Addendum No. 1
August 23, 2024

Project: KOA – Rapid City Office
Rapid City, South Dakota
#3017

Architect: Architecture Incorporated

1 LOWER LEVEL FINISH FLOOR PLAN
4.20 SCALE: 1/8" = 1'-0"

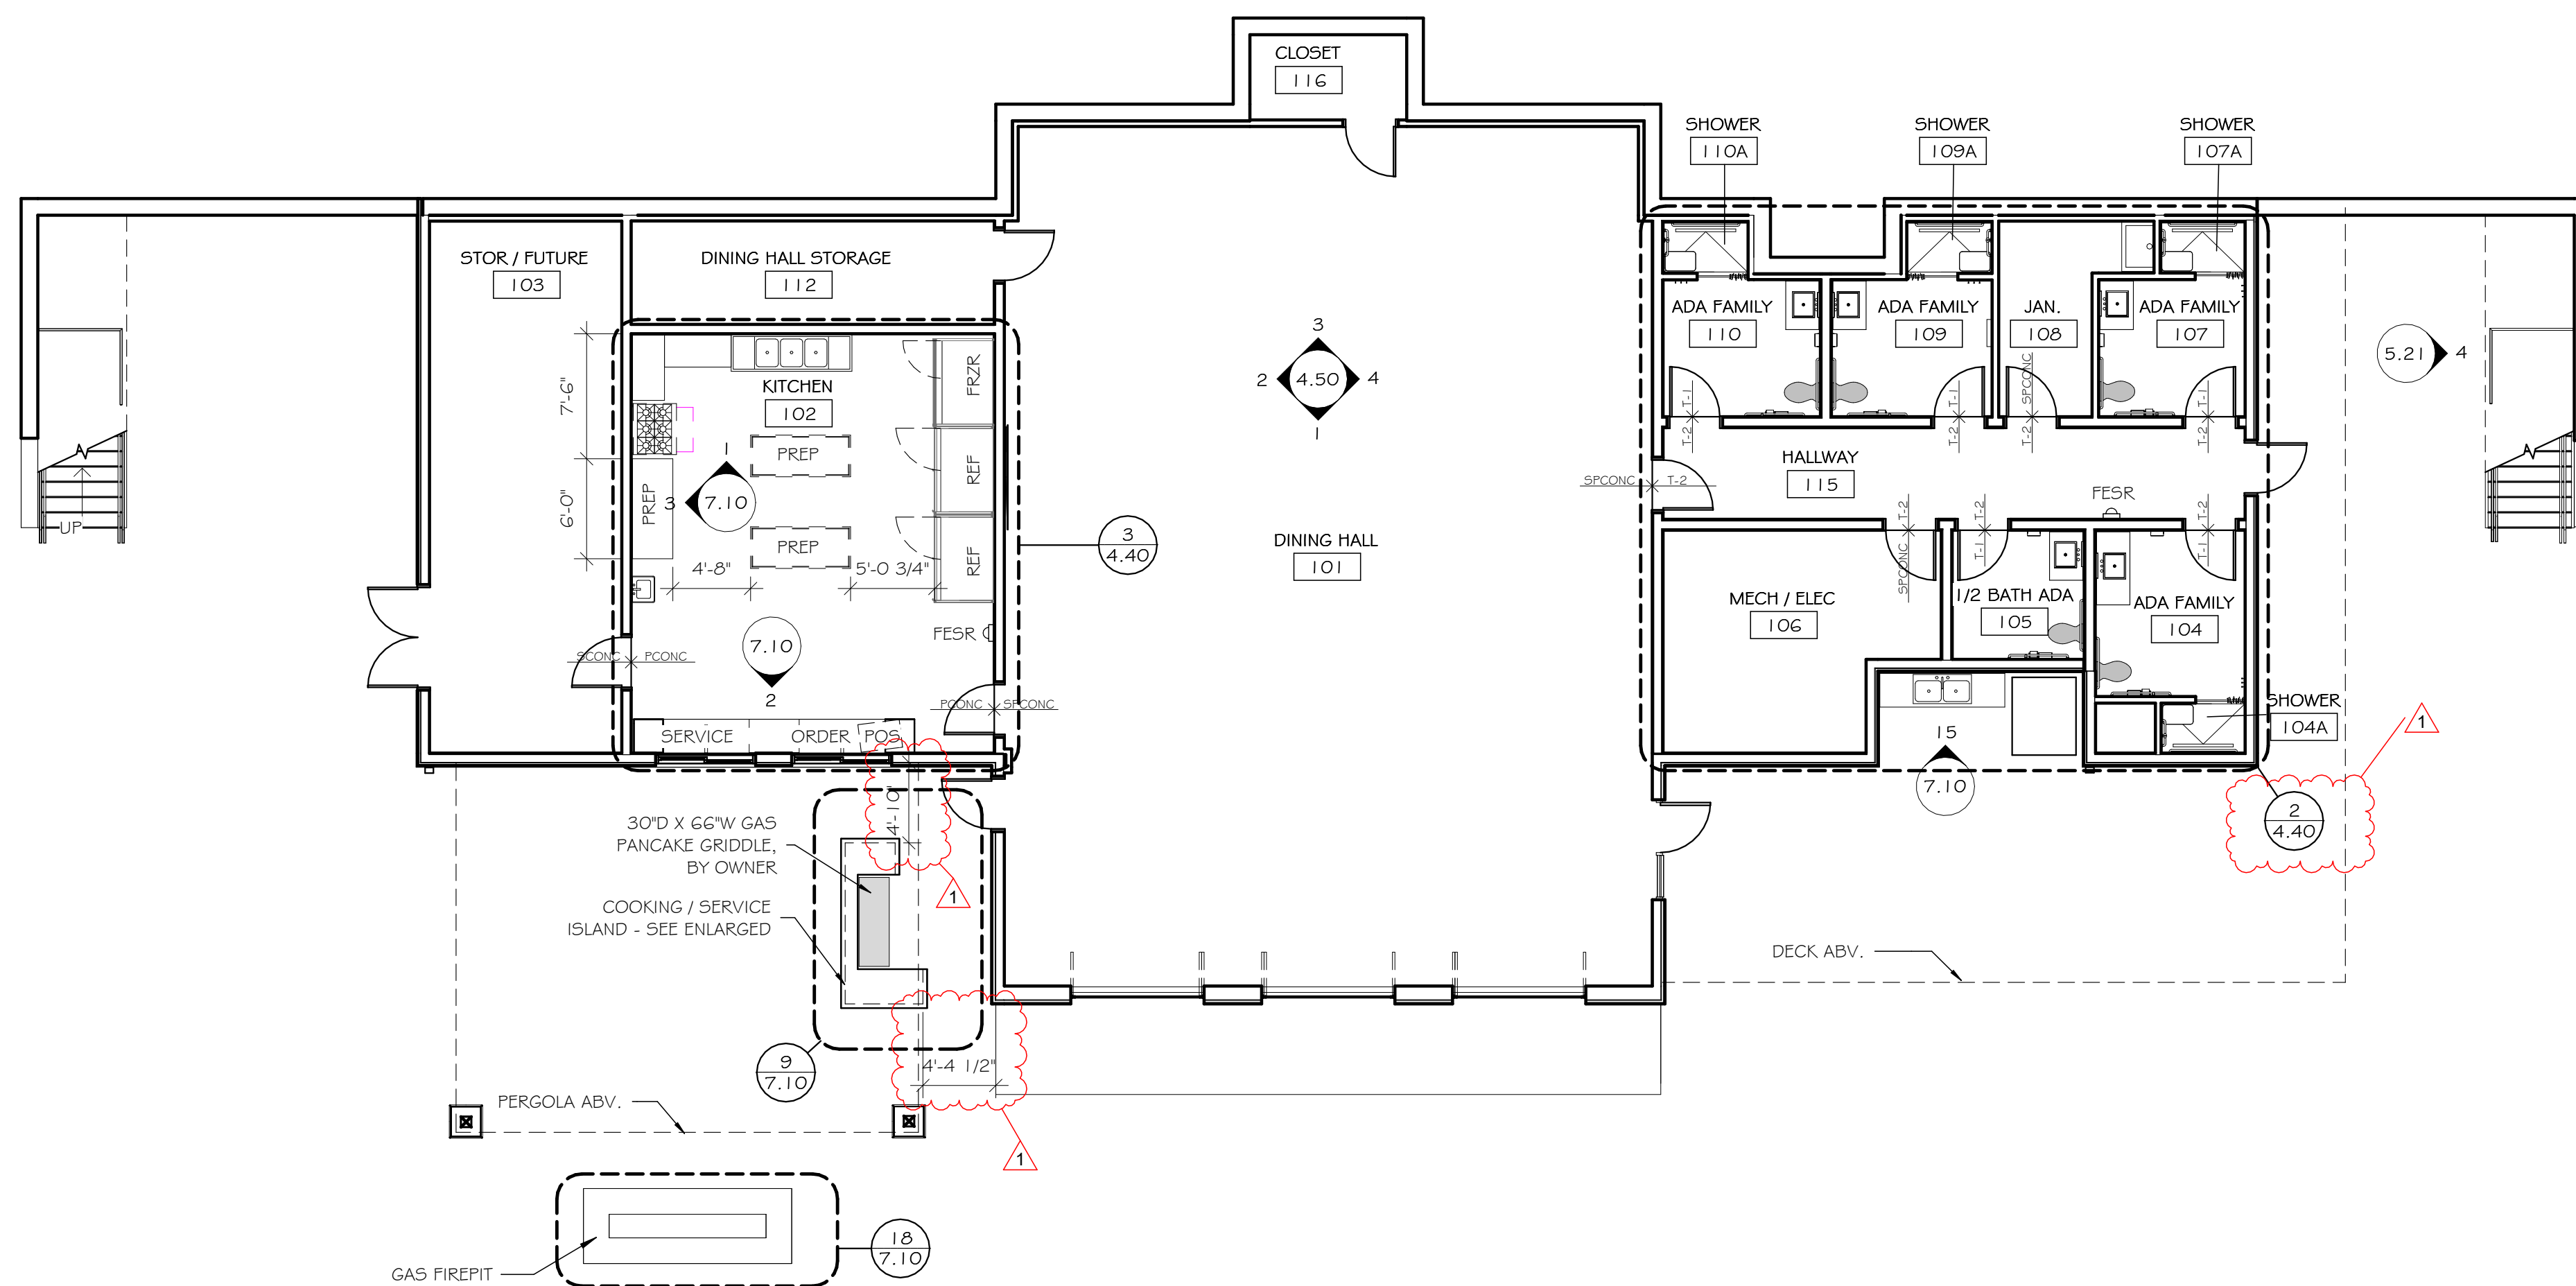
- 8) DRAWING 4.20 –LOWER LEVEL FINISH PLAN
- a) Enlarged Plan Reference number 7/4.33: Changed to Detail 2/4.40 on “Enlarged Plans”.
 - b) Add location dimensions at exterior cooking island.

- c) Room Finish Schedule: Change floor finish in Dining Hall 101 to CPCONC – “Colored Polished Concrete”. The concrete in this room to be integrally colored as per Section 033000 “Cast in Place Concrete”. Color to be selected from manufacturer’s full range.

- d) Room Finish Schedule: Change the following Finishes:
 - i) 101 Dining Hall: Change ceiling finish to ACT-2.
 - ii) 102 Kitchen: Change ceiling to ACT-3.

- iii) 103 Storage: Change ceiling to ES (unfinished).
 - iv) 108 Janitor: Add FRP to wall finish.
 - v) 112 Dining Hall Storage: Change ceiling to ACT-1.

- e) Revised sheet 4.20 is attached, with changes clouded and noted as “1”.
- 9) DRAWING 4.21 –UPPER LEVEL FINISH PLAN
- a) Enlarged Plan Reference number 7/4.33: Changed to Detail 2/4.40 on “Enlarged Plans”.

UPPER LEVEL FINISH FLOOR PLAN
SCALE: 1/8" = 1'-0"

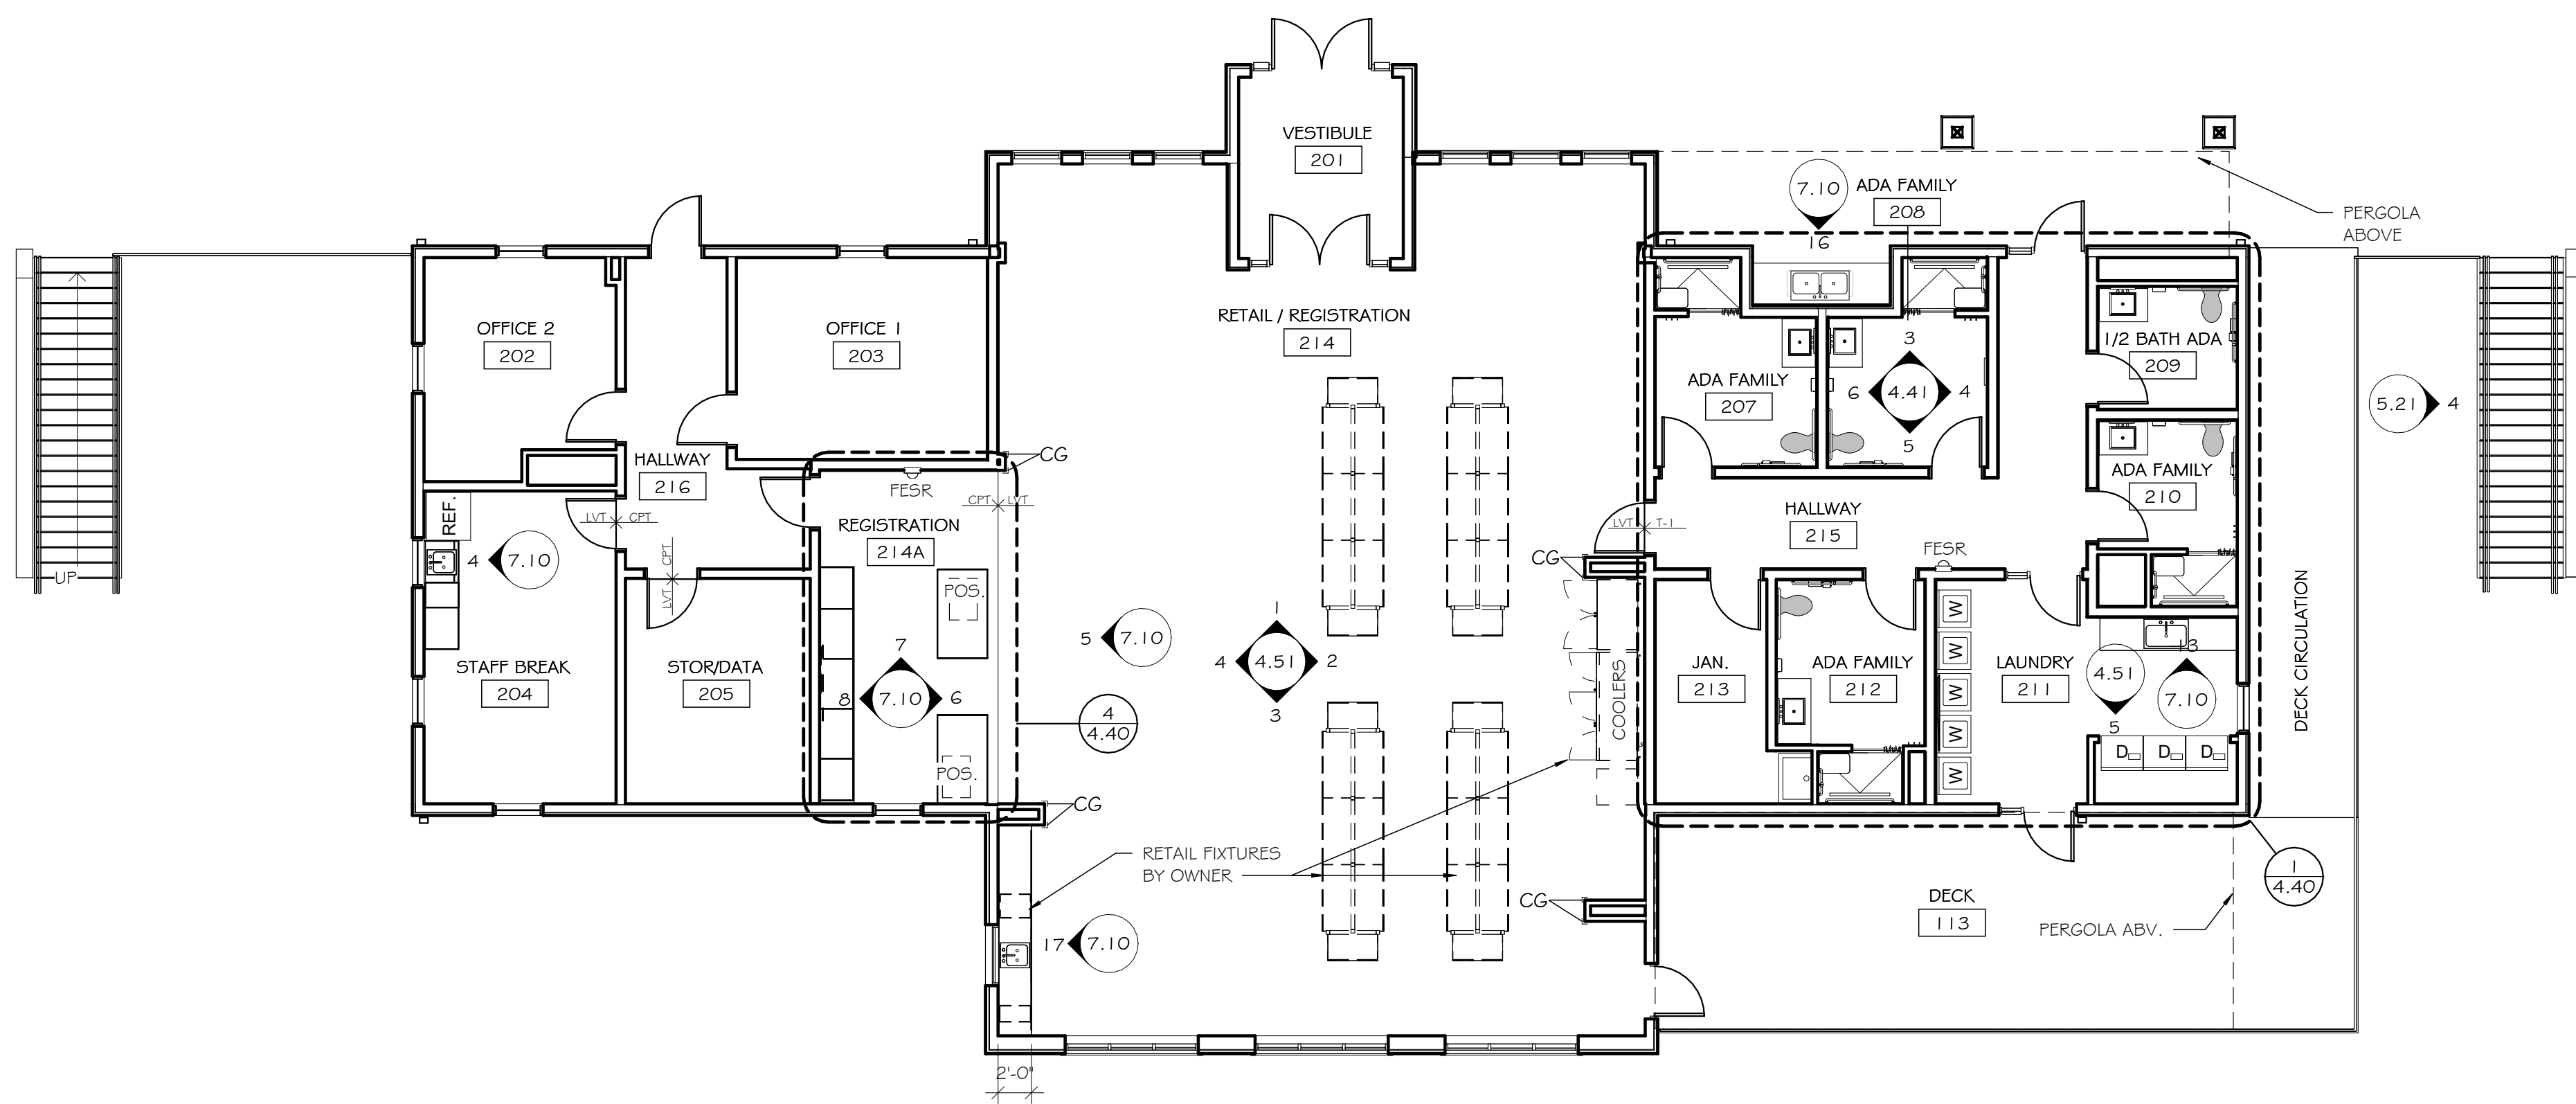
- b) Room Finish Schedule: Retail 214 – add wall finish designation”STONE” for the stone veneer on the north end at vestibule.
 - c) Room Finish Schedule: Change the following Finishes:

- i) 201 Vestibule: Change ceiling to PNT-2 on gypsum board.
 - ii) 213 Janitor: Add FRP to wall finish.
 - iii) 214A Resgistration: Add PNT-2 to ceiling finish.

- d) Revised sheet 4.21 is attached, with changes clouded and noted as “1”.
- 10) DRAWING 4.40 –ENLARGED PLANS
- a) Accessory Schedule: Changes in “Notes” column :

3
4.40 ENLARGED KITCHEN PLAN
SCALE: 1/4" = 1'-0"

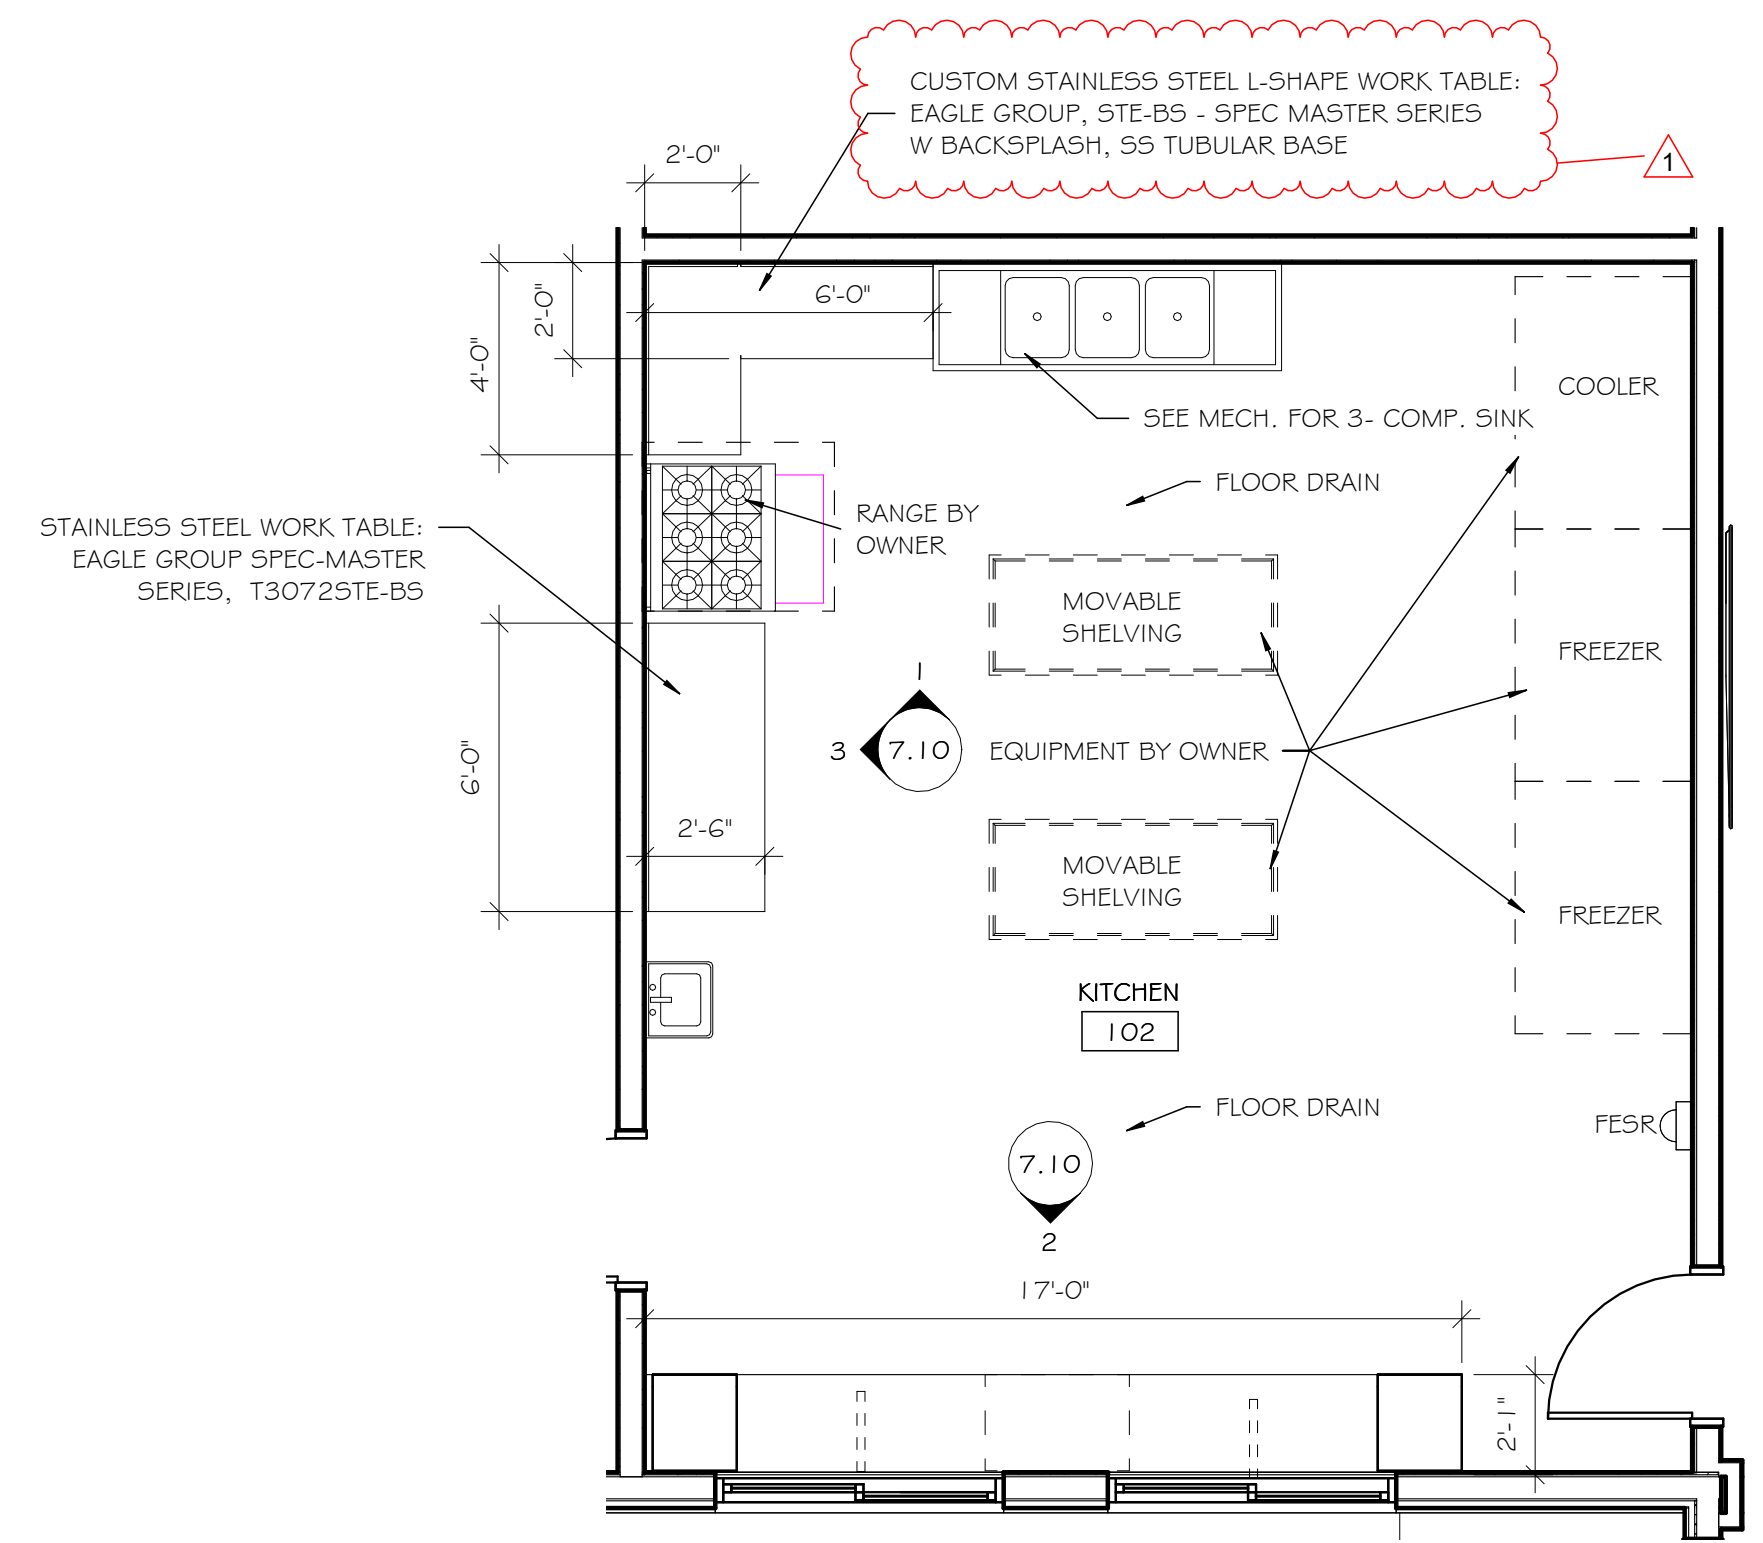
- iv) Item “V” Babychanging Station” revised to include Note #9 – “Refer to Manufacturer’s Installation Instructions”.
 - b) Detail 3 / 4.40 Enlarged Kitchen Plan: L-shape work Table note revised to clarify that the top is to be L-shape seamless construction.
